Access Compliance Report Public Rights-of-Way (Curb Ramps)

Main Street: ANDAZA_ST		Cross Street: AIROSO_ST		Location:	S
ADA ID: RPRK211203120744	Ramp Type:Type 1 - Perpendicular	Initial Pass/Fail: Fail	Overall Compliance: No	Severity Score:	15
Codes/Mitigation Info/Possible Solution			Field Measurements/Component Compliance

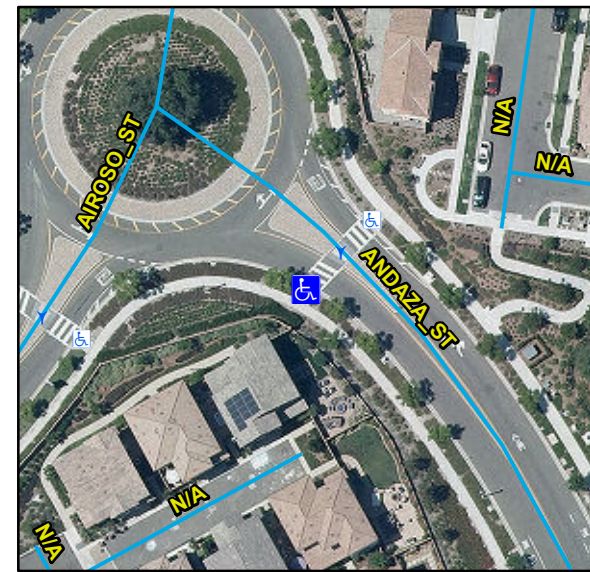
Compliance	Description	Data	Compliance	Description	Data
N/A	Ramp Length (in)	97	N/A	Flare Type LT	
Yes	Ramp Width (in)	62			N/A
Yes	Ramp Run Slope (%)	6.9	N/A	Flare Slope LT (%)	N/A
No	Ramp Cross Slope (%)	6.5	N/A	Flare Traversable LT	N/A
N/A	Landing Present	N/A	N/A	Flare Type RT	
N/A	Landing Length (in)	N/A			N/A
N/A	Landing Width (in)	N/A	N/A	Flare Slope RT (%)	N/A
N/A	Landing Run Slope (%)	N/A	N/A	Flare Traversable RT	N/A
N/A	Landing Cross Slope (%)	N/A	N/A	DWS Provided	N/A
N/A	Landing Movement Obstructed?	N/A	N/A	DWS Contrast	N/A
	Landing Movement Type	N/A	N/A	DWS Length (in)	N/A
N/A	Landing Shared	N/A	N/A	DWS Full Width	N/A
N/A	Clear Space	N/A	N/A	DWS Offset Left (in)	N/A
N/A	Clear Space To Crosswalk (in)	N/A	N/A	DWS Offset Right (in)	N/A
N/A	Marked Crosswalk 1	Yes	N/A	Marked Crosswalk 2	N/A
	Crossing 1 Direction	E		Crossing 2 Direction	N/A
	Marked Crosswalk 1 Width (in)	144		Marked Crosswalk 2 Width (in)	N/A

Remove & Replace Entire Ramp.

R304.5.3, STD 1115
